Änderungen (nach ÄZ „h")

Modifications

Stromlauf

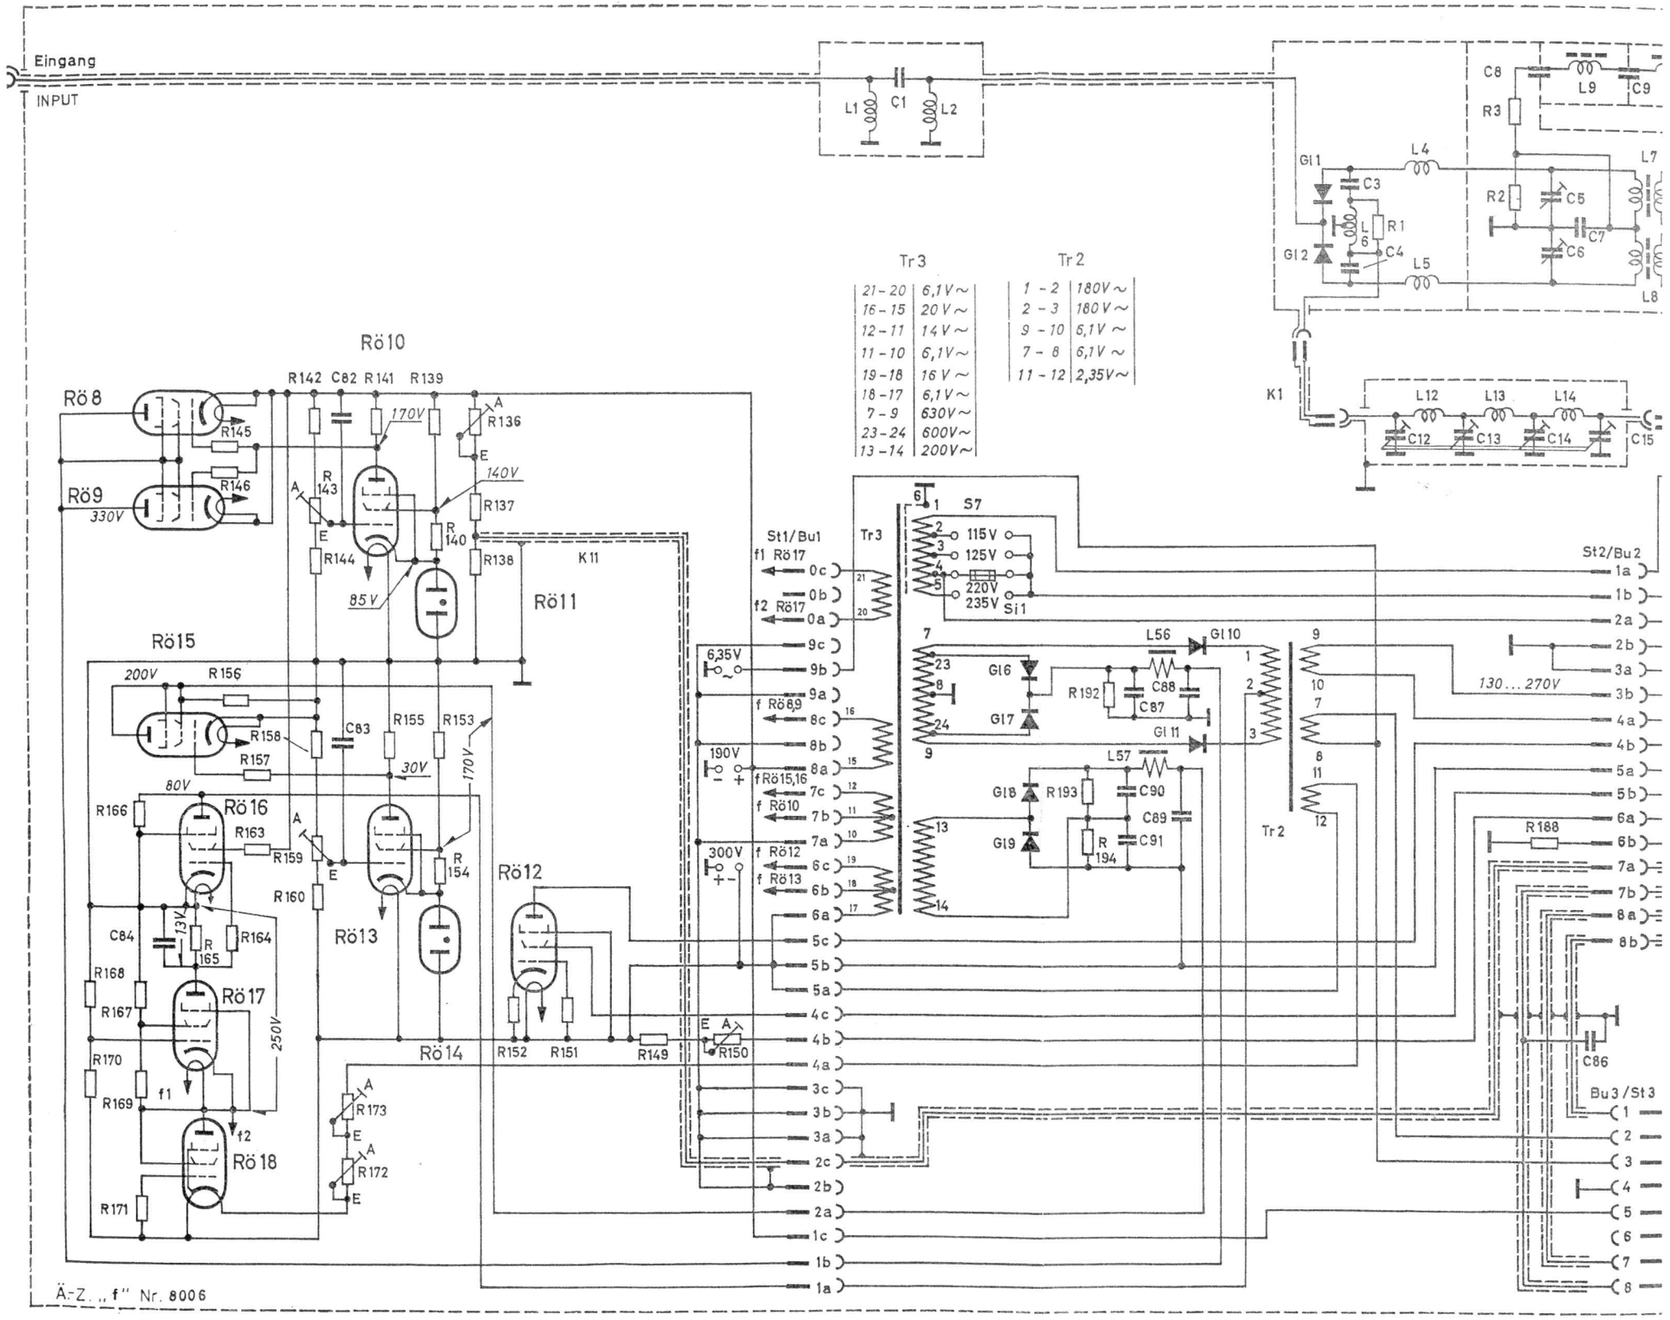
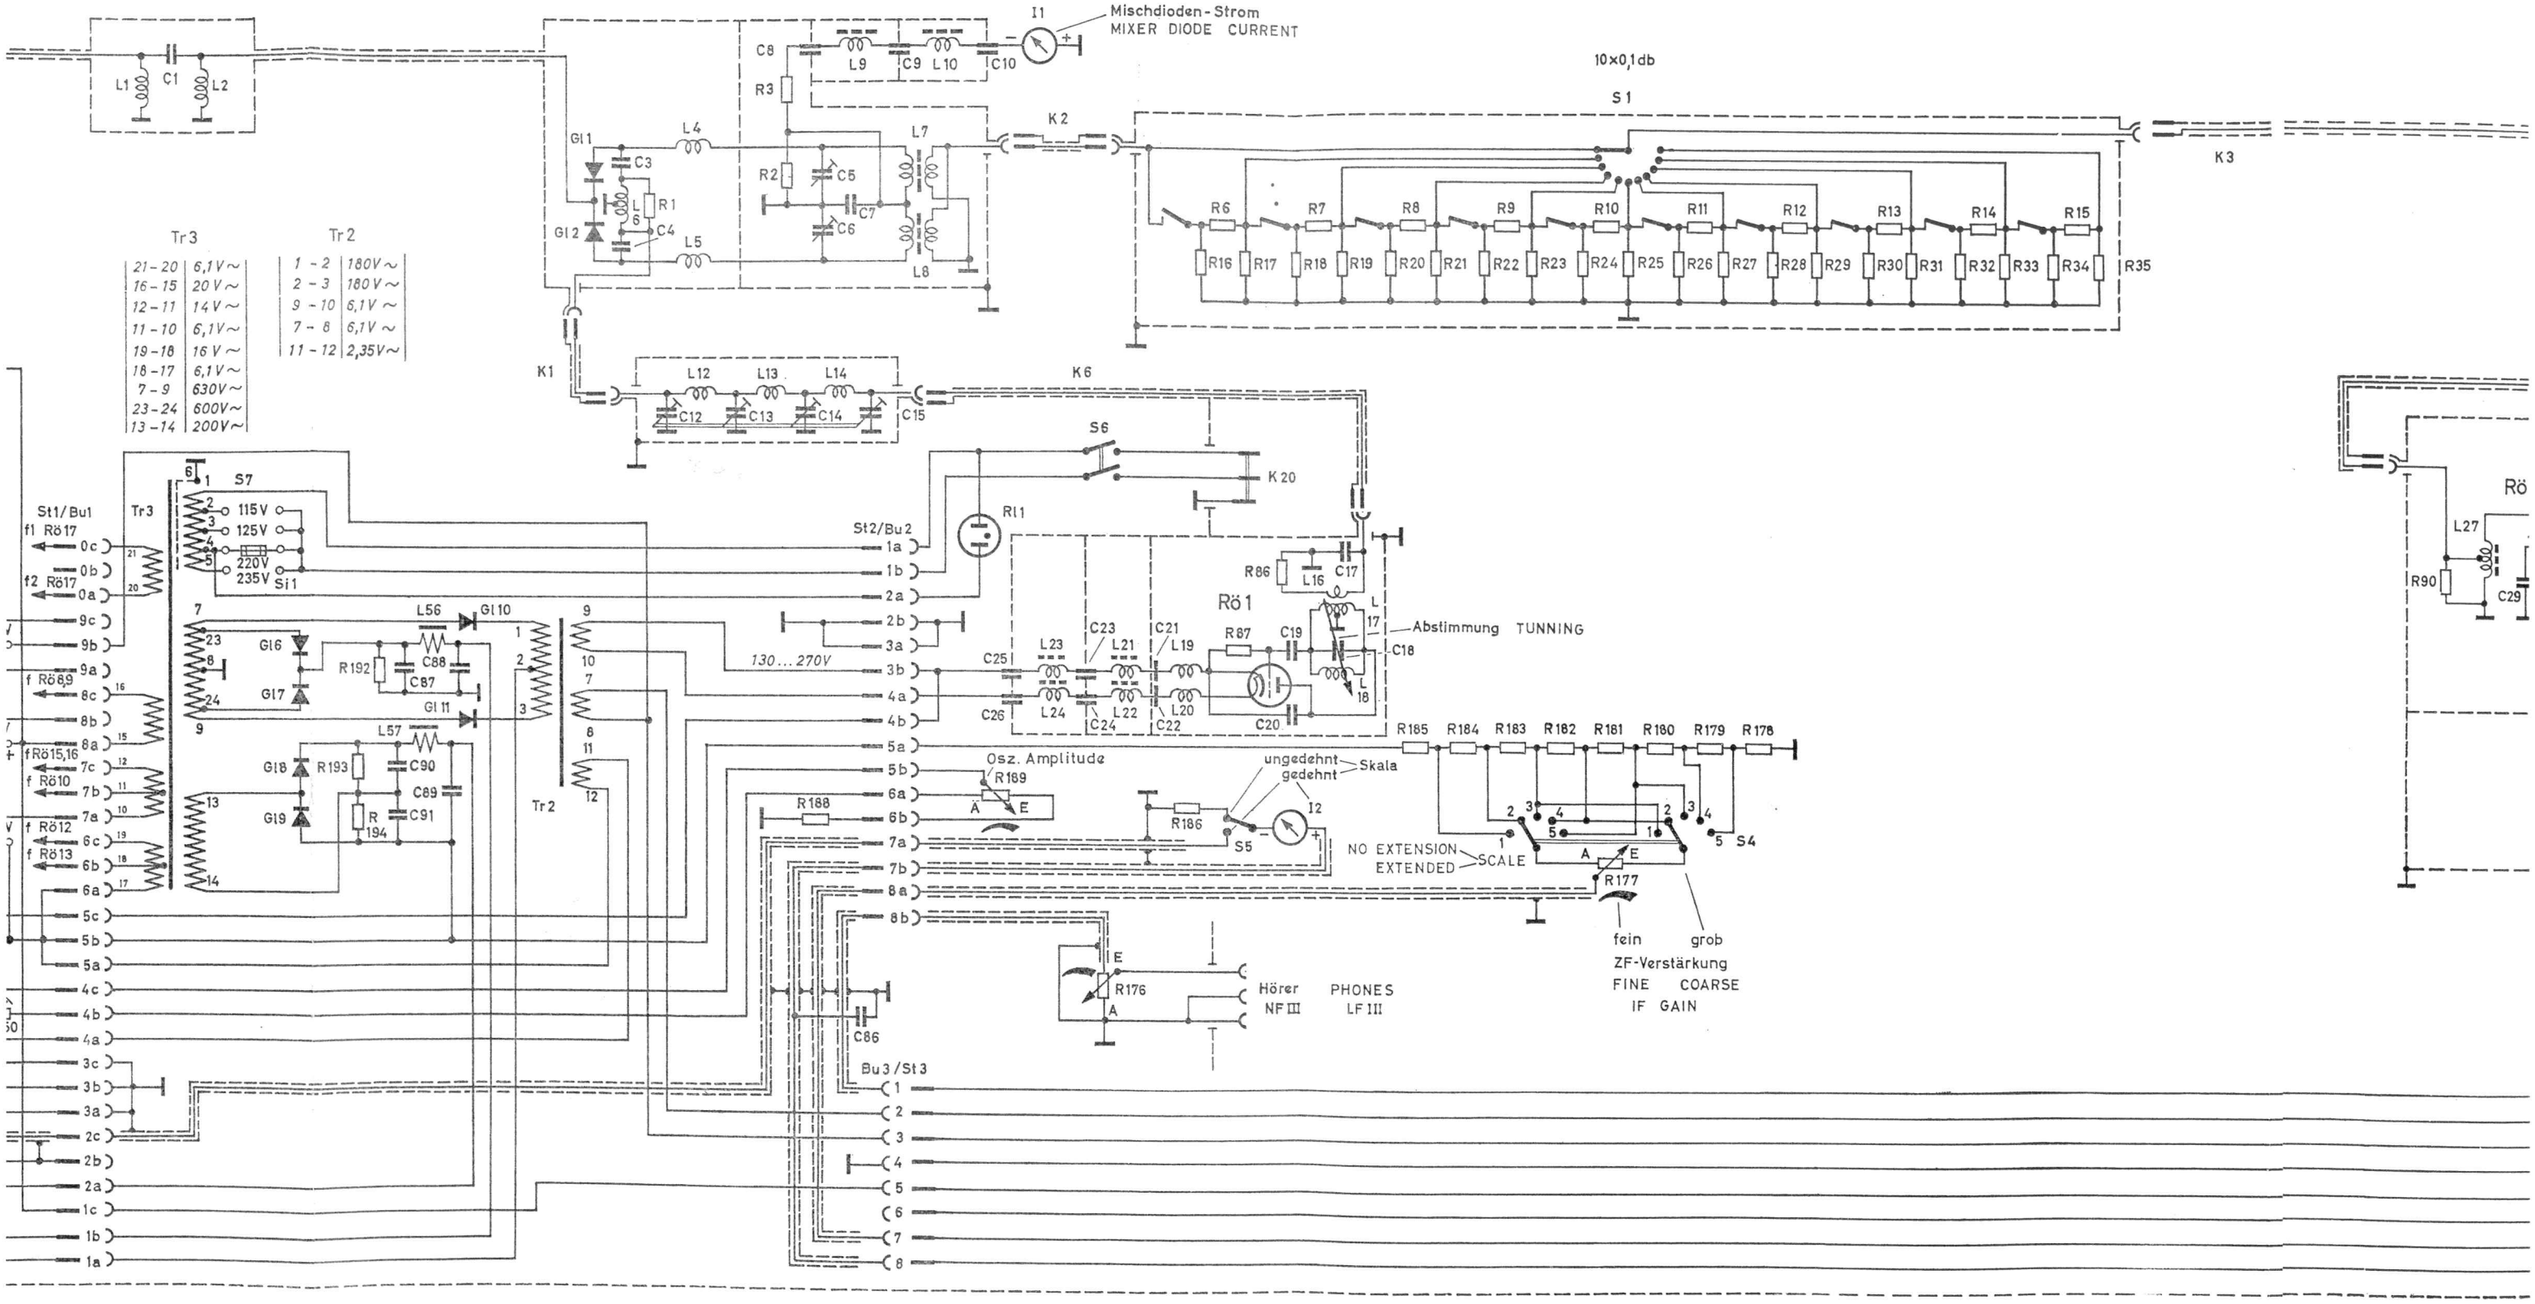
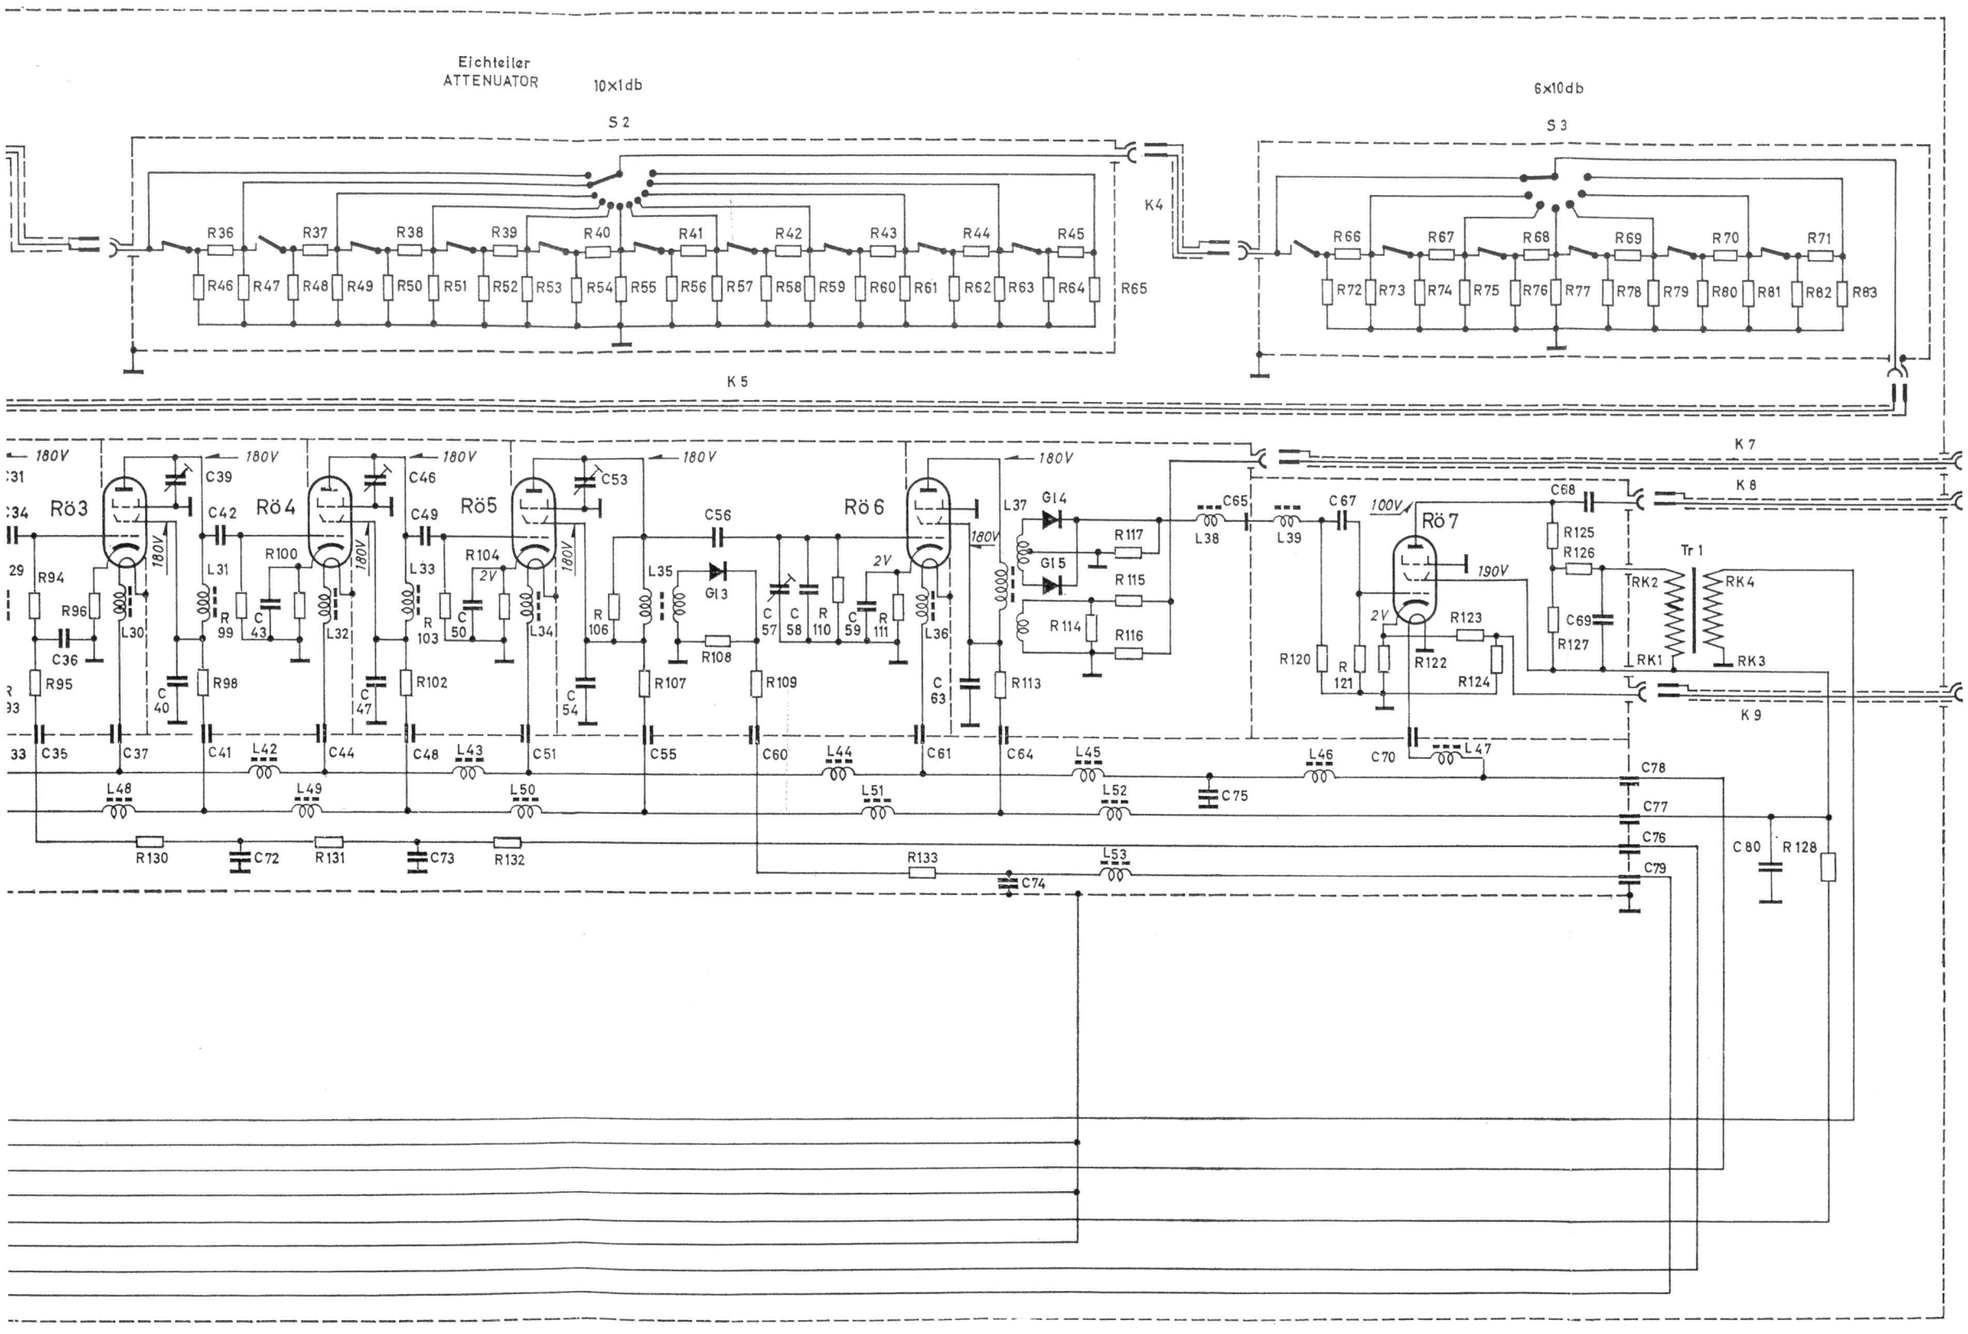
In der Mischstufe (Gl1-Gl2) ist die Leitung zwischen Buchse und R1-L6-C4 abgeschirmt.

Die Instrumente haben nicht die Kennzeichen I1 und I2, sondern J1 und J2.

Am Eingang von Rö2 ist R90 nicht ein Festwiderstand zwischen der Anzapfung von L27 und Masse, sondern ein Regelwiderstand parallel zur ganzen Spule L27.

In the mixer stage (GI1-GI2), the lead between socket and R1-L6-C4 is shielded.

The instruments are designated J1 and J2, not I1 und I2.

At the input of Rö2, R90 is a variable resistor parallel to the entire coil L27, and not a fixed resistor between the tap L27 and chassis.
